MEMORANDUM

RE: Revised Plans for 15 Meriwether Court (COFA-01-25-019522)

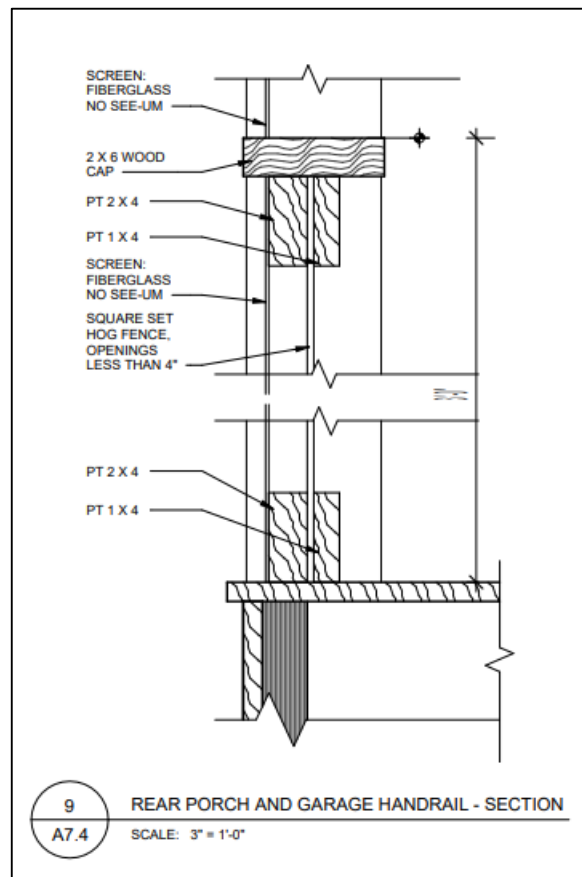
13. The Commission has requested additional information on the proposed materials for the fencing, using the wire mesh.

The front porch railing has been removed, but wire mesh is proposed for the patio connecting the main structure to the garage. The below graphic indicates that the square openings for the hog fence will “less than 4”.”
